## Product Change Notice (PCN)

PCN Number: **PCN-0450879R-01**

Product(s) Affected: **PJ1-021**

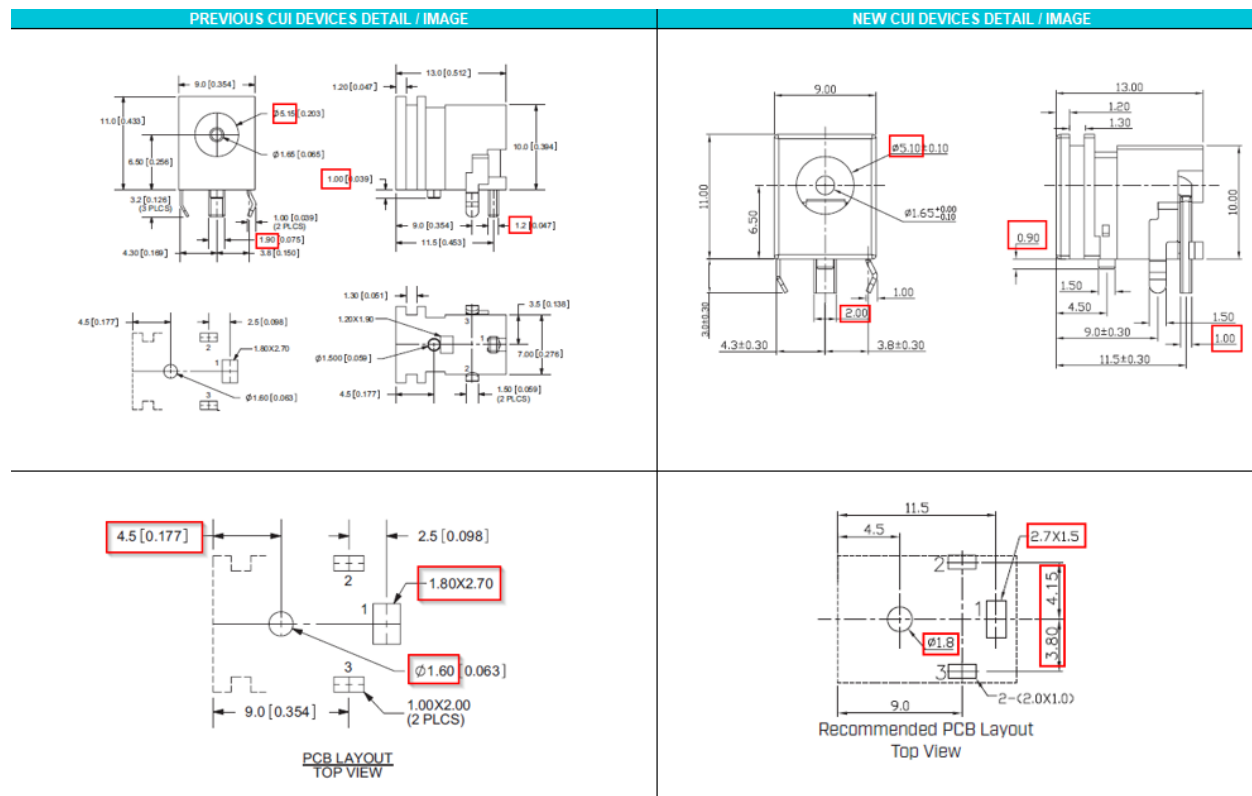
Description of Change: **Minor Housing and footprint differences. Material Change on the housing and terminals. See image Below**

PREVIOUS CUI DEVICES DETAIL / IMAGE			NEW CUI DEVICES DETAIL / IMAGE		
	MATERIAL	PLATING			
center pin	copper	silver	DESCRIPTION	MATERIAL	PLATING/COLOR
terminal 1	copper	silver	center pin	brass	nickel
terminal 2	copper alloy	silver	terminal 1	brass	nickel
terminal 3	brass	silver	terminal 2	bronze t=0.30	silver
plastic	PBT		terminal 3	brass t=0.40	silver
			housing	PBT (UL94V-0)	black

MATING PLUG  
Jack Insertion Depth: 8.5 mm

MATING PLUG  
Jack Insertion Depth: 8.7 mm
